# Access Compliance Report

## Public Rights-of-Way

| Intersection ID: 29795 | Main Street: BRISTLE_TOE_LN | Cross Street: CHELTON_RIDGE_LN | Location: NE           |
| ADA ID: 5E63BDEAFC9A   | Ramp Type: Combination1Diag | Initial Pass/Fail: Fail        | Overall Compliance: No |

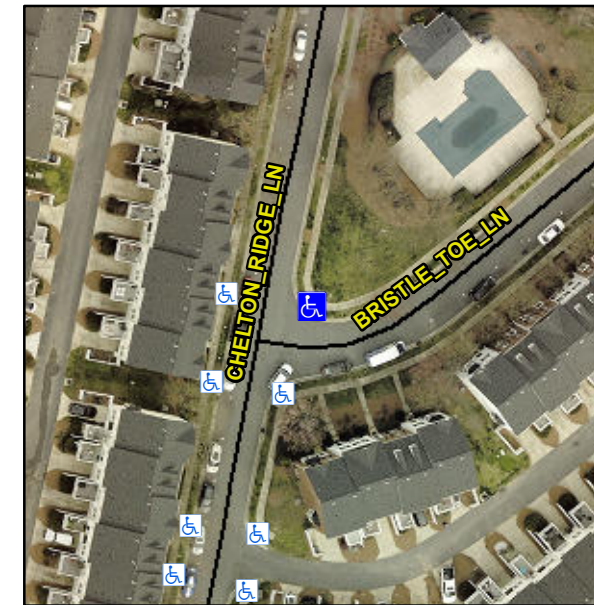
**LT RP < 5%**

**R304.5.1, R304.2.2, R304.5.3**

| Compliance | Description              | Data | Compliance | Description                 | Data |
|------------|--------------------------|------|------------|-----------------------------|------|
| No         | Ramp XSlope LT (%)       | 5.7  | Yes        | Ramp XSlope RT (%)          | 1.6  |
| N/A        | Ramp Length (in)         | 84.0 | No         | Ramp Slope (%)              | 9.0  |
| No         | Ramp Width (in)          | 39.0 | No         | Ramp XSlope (%)             | 6.4  |

**Remove & Replace Curb Ramp With Two New Directional Ramps or Equivalent.**
